Objection Comments re Housing Density & Odour Assessment

OVERVIEW

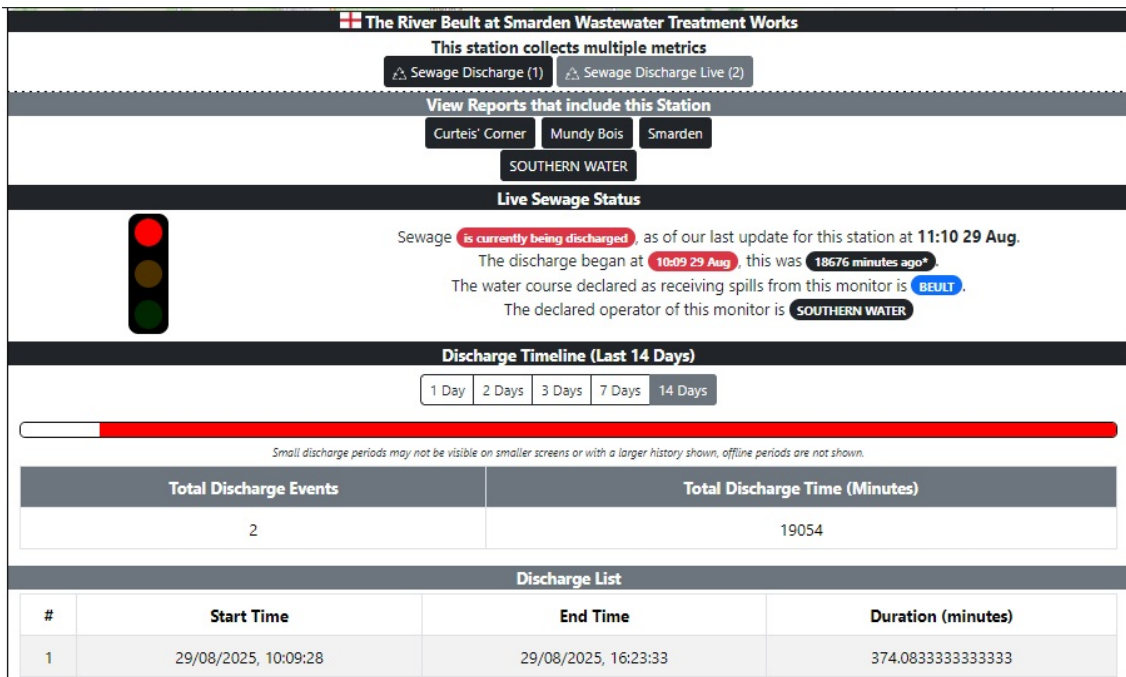
Not in itself Material Consideration for a Planning Objection, Smarden holds the dubious honour of 2nd place ranking in the 2024 league table of sewage pollution sources on the Beult. With its total of 1,333 hrs, narrowly behind High Halden at 1,382. In 2024, the Smarden WWTW discharged sewage for a total of circa 1,091 hrs, the separate downstream Storm Drain discharged a further 242 hrs.

Seemingly, the 'sniff surveys' managed to avoid these events? The only Summer 'dry' period survey was in June and the recent long-awaited arrival of rains at end August has triggered immediate spillages; just one example below. We respectfully suggest that the previous static watercourse might yield some unwelcome fragrances.

For the current Odour Assessment to be considered credible, it needs to be extended to consider the WWTW discharge; however, the highest potential for odours will have been from the current sewage dumps to minimal post-dry-season flows in the watercourse. Evidence of eutrophication is available generally on this section of the river and the potential exists for the generation of significant odours in the river adjacent to the site.
